# FINAL STATEMENT OF BASIS CORRECTIVE MEASURES SELECTION

Former Lockheed Martin-French Road Facility

Operable Units 01 & 02

Site No. 633036A

FIGURE  
**4**

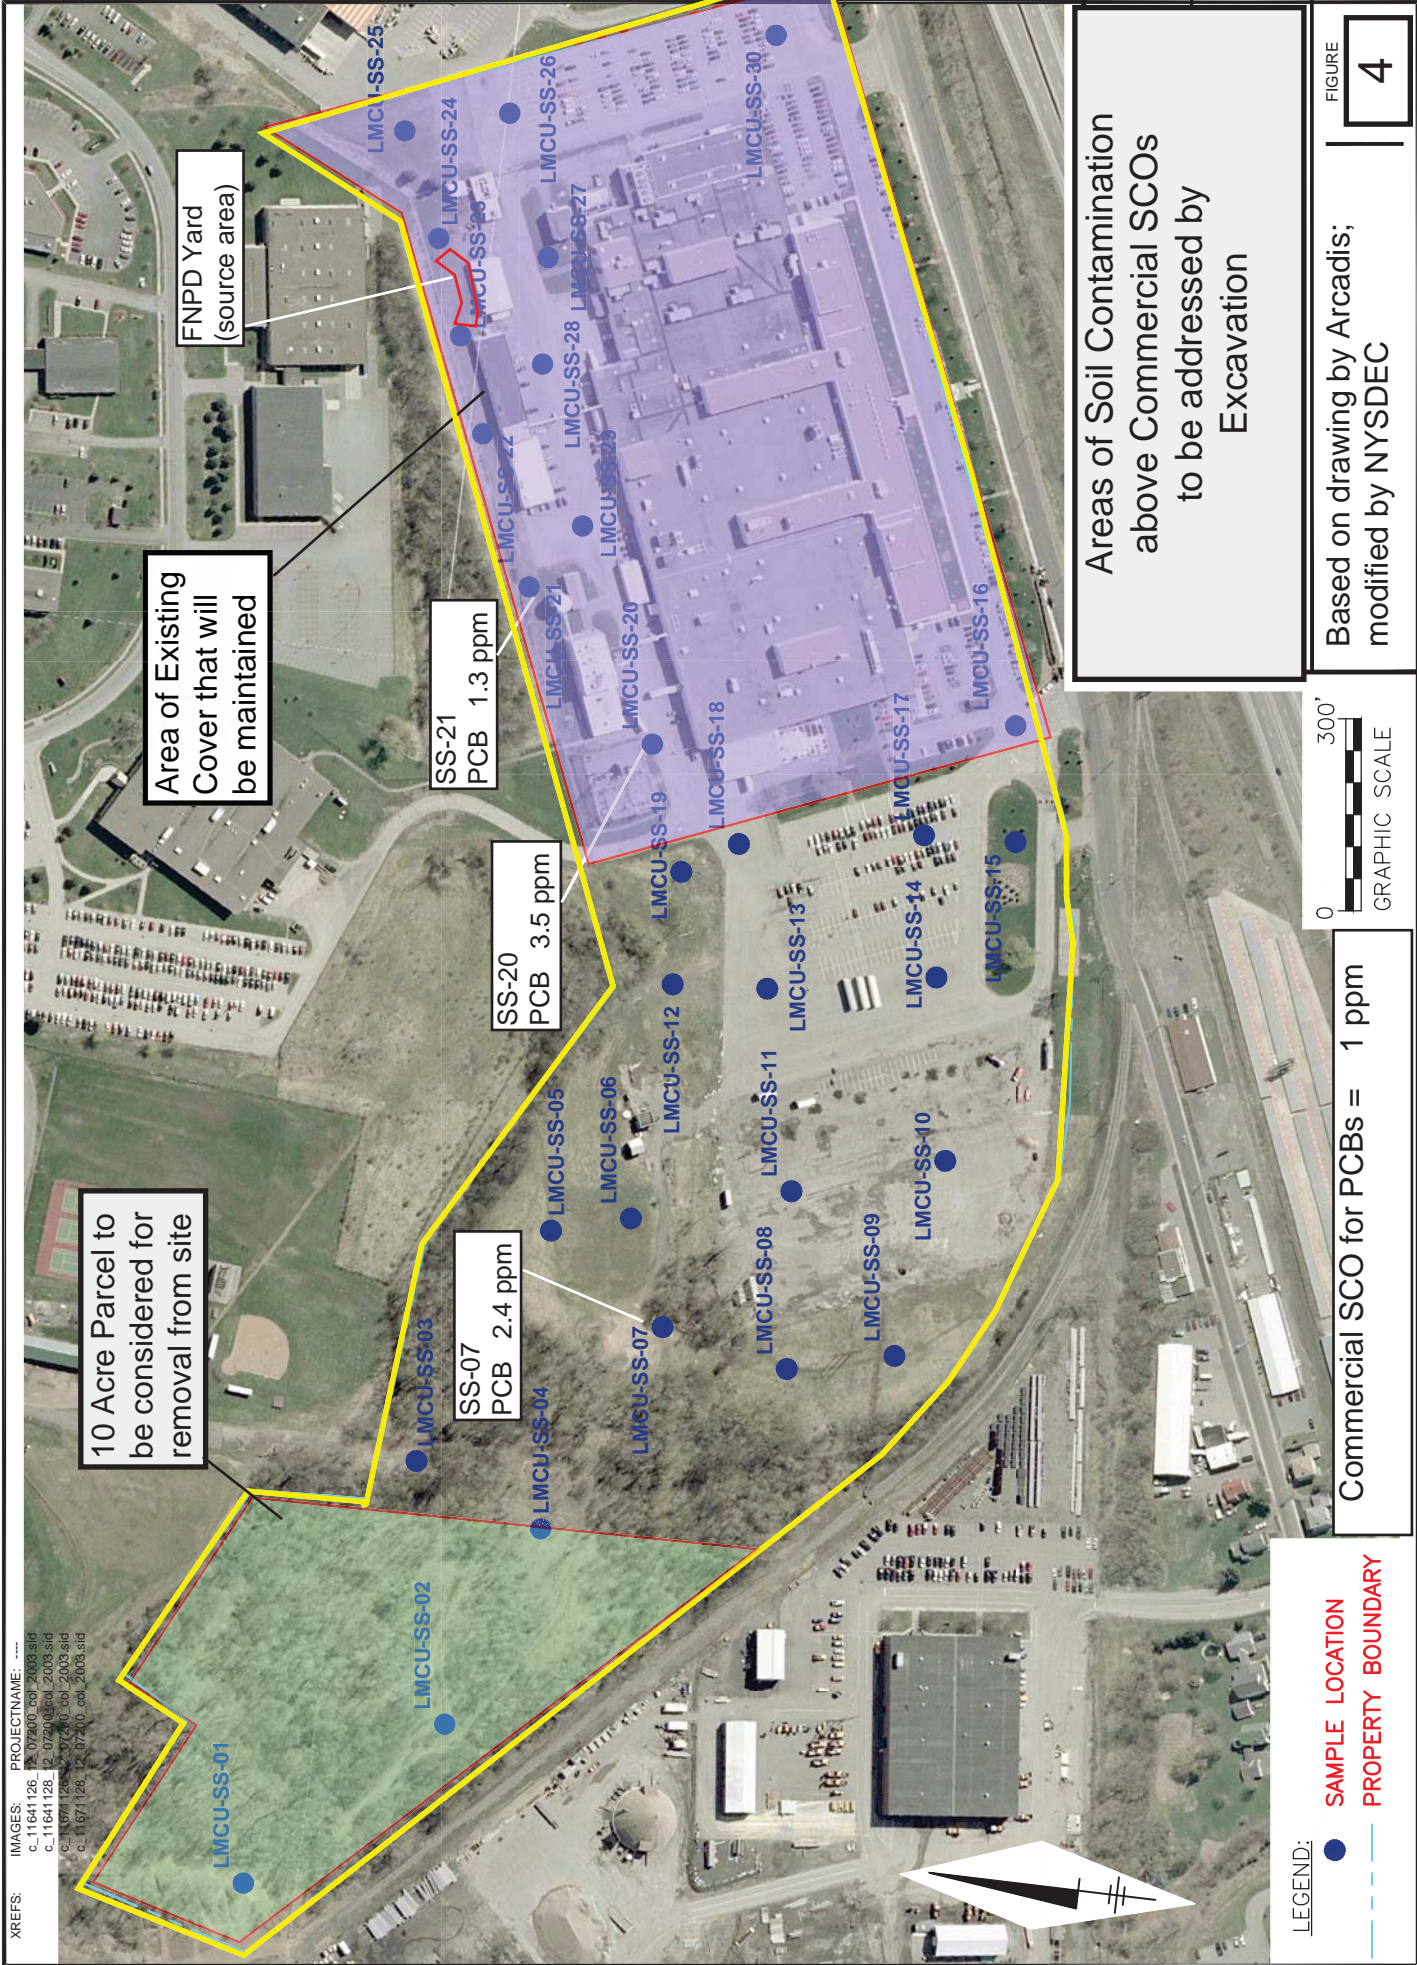
Comment 23: VII Environmental Easement/Site Management Plan. There are four parts of this comment, including that ConMed has not agreed to the placement of an Environmental Easement or to the components of the Site Management Plan (SMP) described in the Statement of Basis, that a map be provided showing the area proposed for removal from the site as well as the area subject to the SMP, that future actions are Lockheed Martin's responsibility and clarification of the extent of the Soil Excavation Plan.

Figure 4 of the Statement of Basis provides a depiction of the property that is proposed for removal from the site. The Soil Excavation Plan would apply to areas of remaining groundwater contamination, which is not limited to the area around the maintenance building.

**Figure 6**

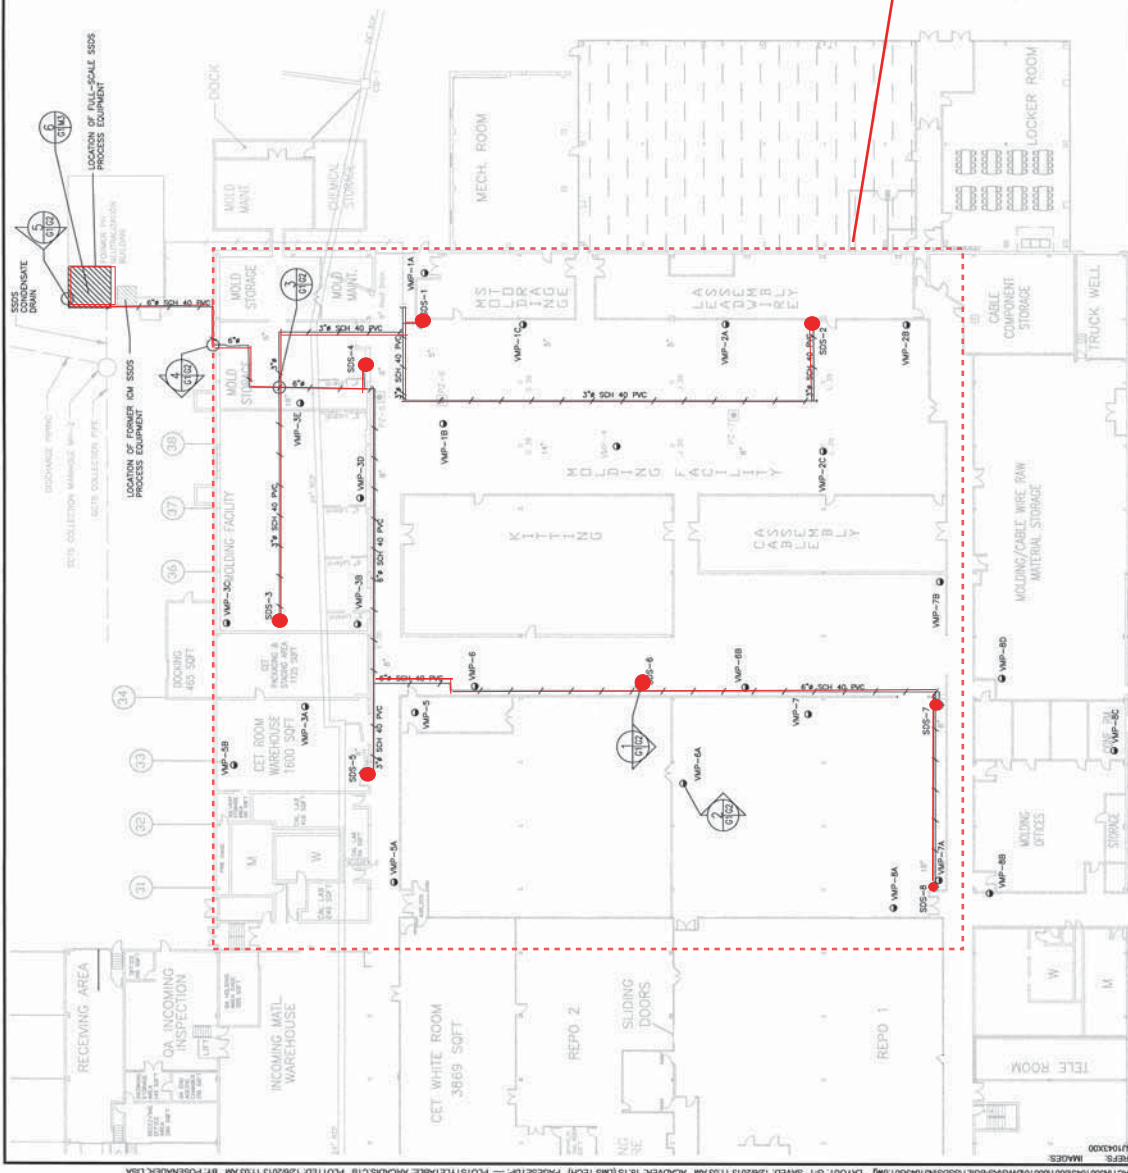
Comment 6: Page 10, Item #4: “The sub-slab depressurization system in the eastern portion of the Main Manufacturing building will be required to continue operation to prevent the migration of vapors into the building from groundwater until NYSDEC, in consultation with NYSDOH, determines that it is no longer needed.”

Comment: The determination of when cessation of SSDS operation can occur should be based on a tangible criteria. Lockheed welcomes the opportunity to work with NYSDEC/NYSDOH to establish clearer guidelines for establishing SSDS shut-down criteria.

- Comment 15: III Existing SSDS/ Soil Vapor Intrusion  
In bullet (1), ConMed requests clarification that the SVI system is mitigating the north east portion of the main manufacturing building.

Response 6: Comment noted. The appropriate criteria to cease operation of the SSDS can be discussed during development of the Site Management Plan. In general, the New York State Department of Health Guidance for Evaluating Soil Vapor Intrusion in the State of New York – October, 2006 will be followed, specifically section 4.5.

- Response 15: Agreed. Wording in the SB has been revised.
- Comment 16: Bullets 2 and 3 request further information and justification for statements relative to residual presence of CVOCs, primarily trichloroethylene (TCE), in the Main Manufacturing Building. ConMed requests clarification that there is no direct correlation with indoor air detections of TCE and the past use of TCE by ConMed. It also requests identification of areas where Lockheed Martin used TCE at the site.
